SHEARON HARRIS NUCLEAR POWER PLANT
UNIT NO. 1 - DOCKET NO. 50-400
SOLID STATE LOGIC PROTECTION SYSTEM TEST CIRCUIT

FCN NUMBER
CQLM-10593
SHOP ORDER NUMBER
CQL-387

ITEM NAME Output Relay Test Panel Mod.		ITEM NUMBER	SYSTEM Reactor Protection System	PROJECT CQL
SPIN ESELSP01	CHANGE CONTROL NUMBER (if applicable) 6156	ORIGINAL PURCHASE ORDER	NEW PURCHASE REQ. NUMBER (if applicable) 463816	
ARE DRAWING REVISIONS REQUIRED? YES <input checked="" type="checkbox"/> NO <input type="checkbox"/>		APPLICABLE DRAWINGS AND REVISIONS See Below		
IF YES, METHOD GENERAL ASSEMBLY <input type="checkbox"/>		DESIGN/SHOP DWGS. <input type="checkbox"/> MASTER DWG. LIST <input checked="" type="checkbox"/>		
DRAWINGS TO BE REVISED BY <input type="checkbox"/> WRD <input type="checkbox"/> OTHER (SPECIFY) <input checked="" type="checkbox"/> VENDOR		UPDATED DRAWINGS/ATTACHMENTS <input checked="" type="checkbox"/> ATTACHED <input checked="" type="checkbox"/> TO FOLLOW <input type="checkbox"/> WILL NOT BE SENT		DRAWING STATUS DRAWINGS REVISED (Date) MASTER DRAWING LIST REVISED (Date)

SUBJECT: Modify the Solid State Protection System (SSPS) output relay test panel for Shearon Harris to insure detection of a po

1083HG1 E 17

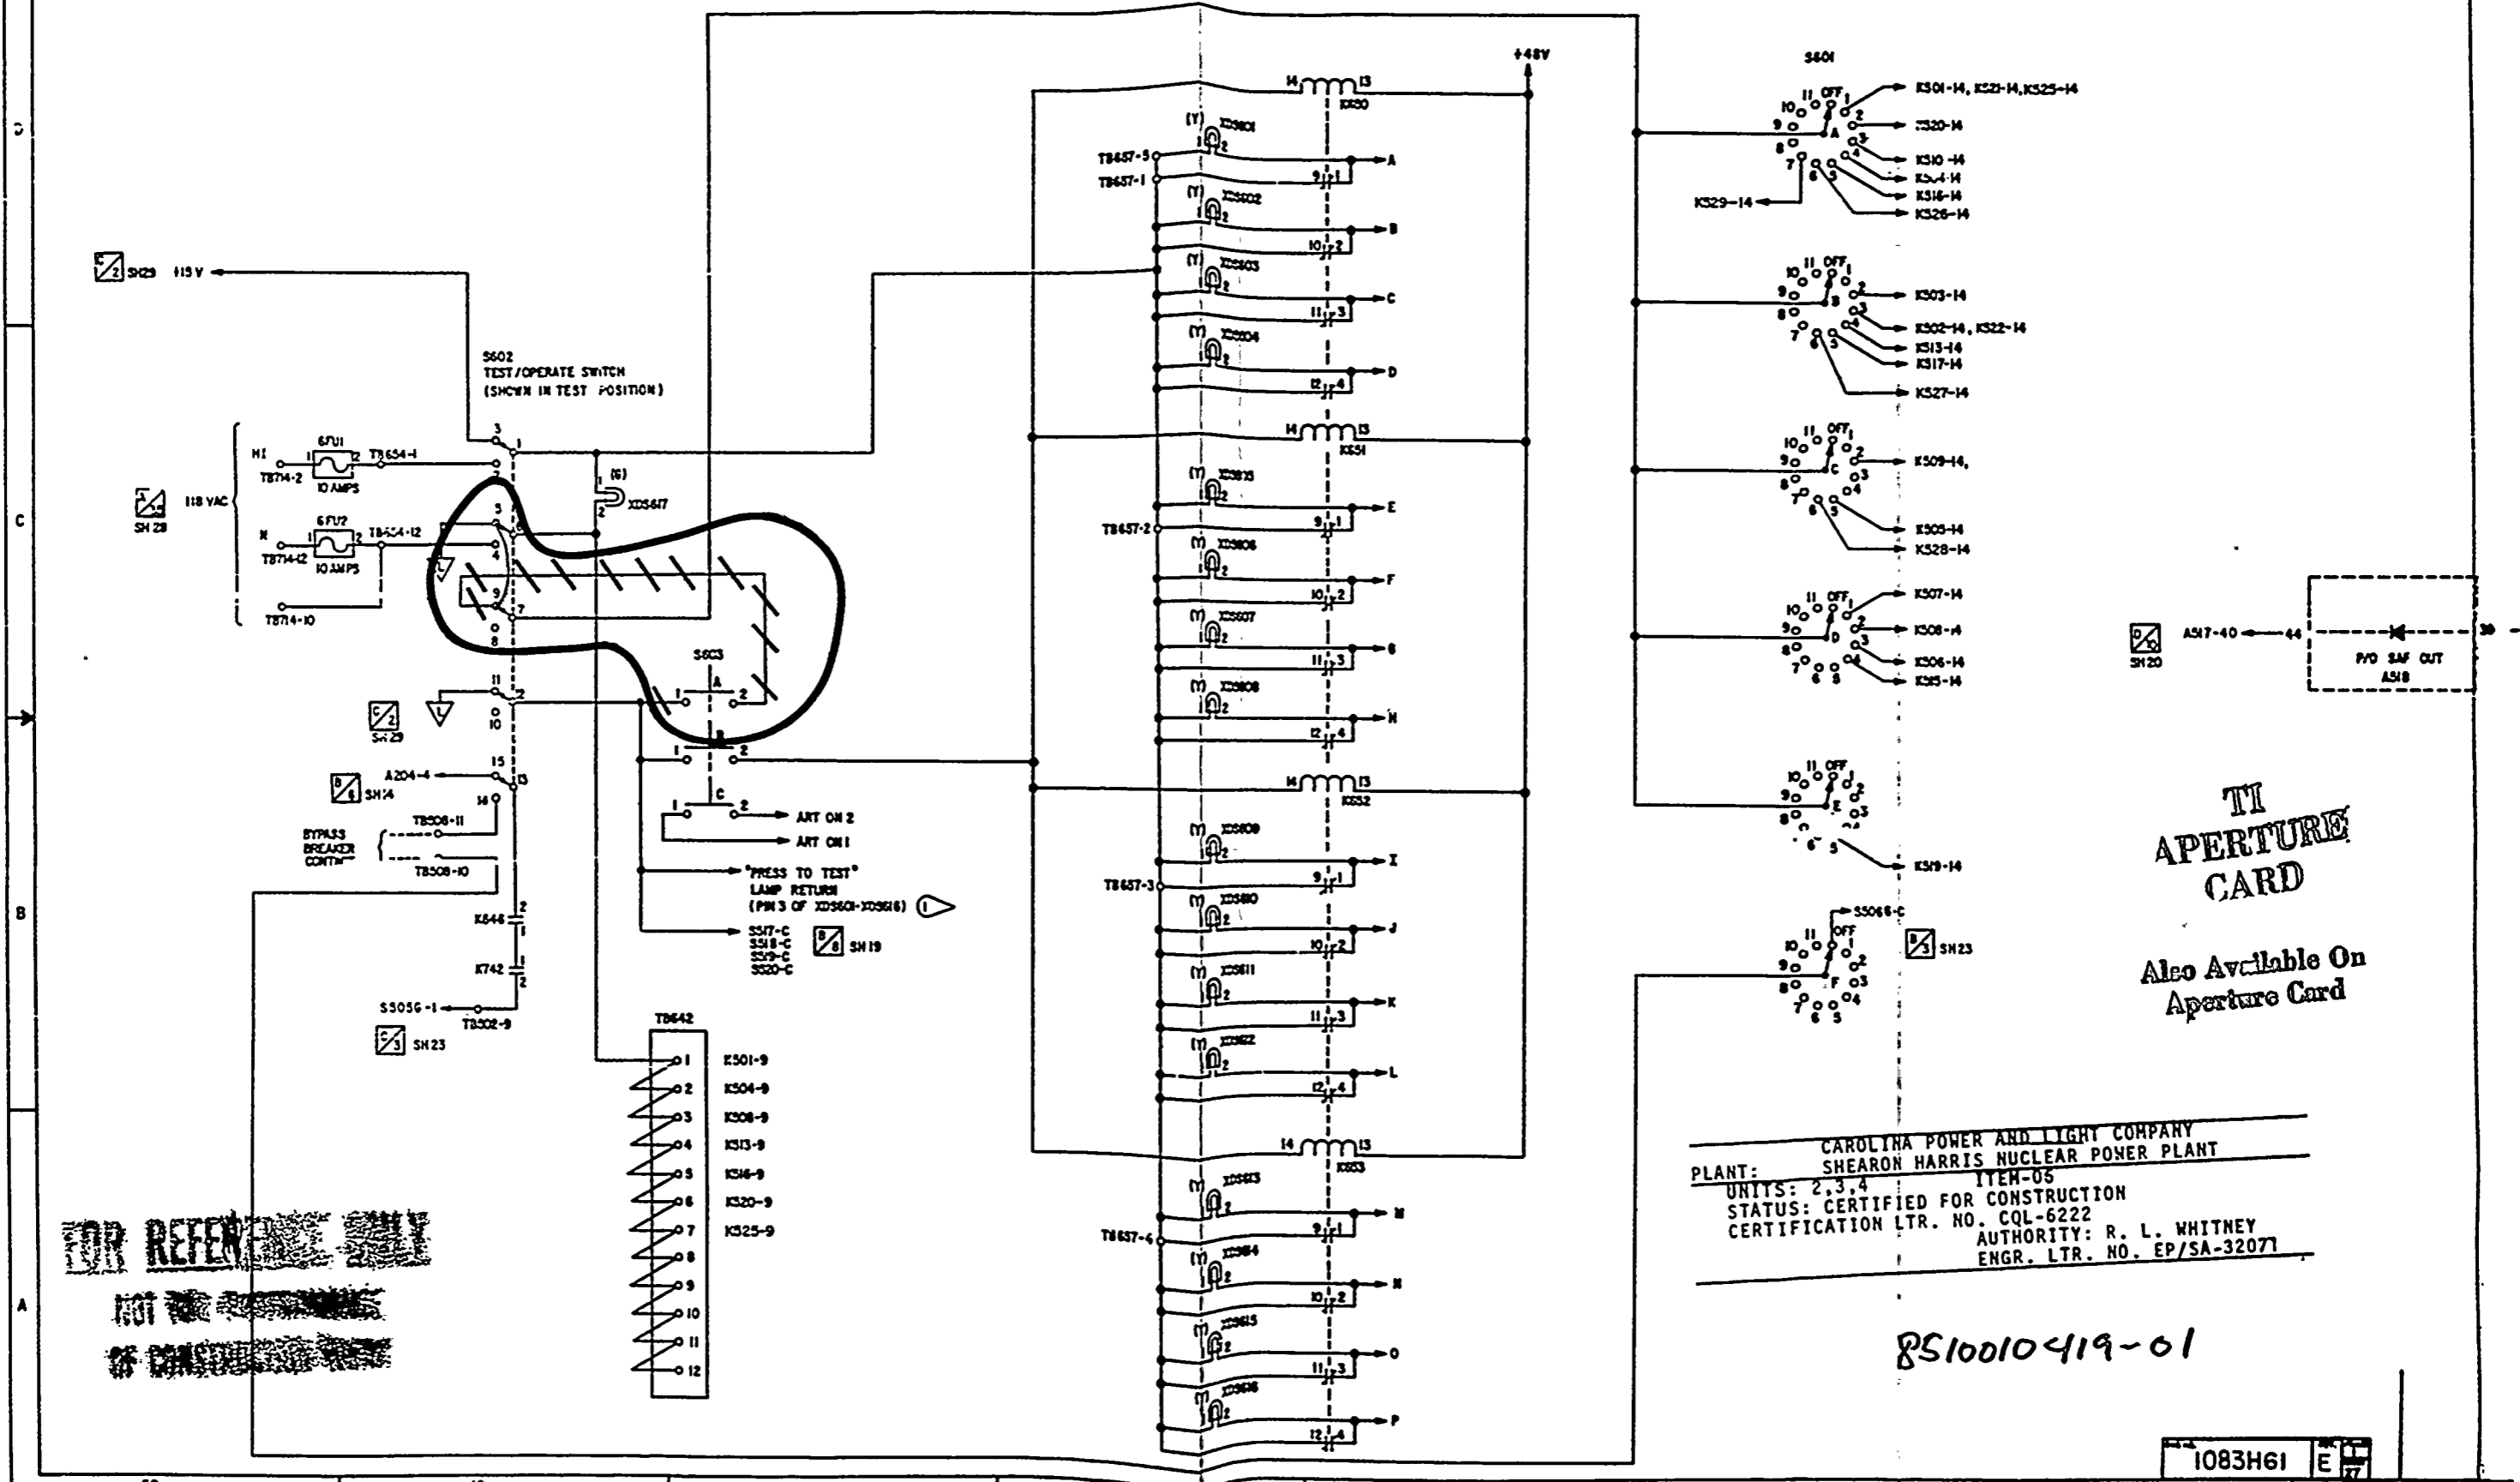
REFERENCE DRAWINGS: The following attached drawings have been marked to reflect the necessary information to complete this change. Revised schematic and wire list will be formally transmitted at a later date.
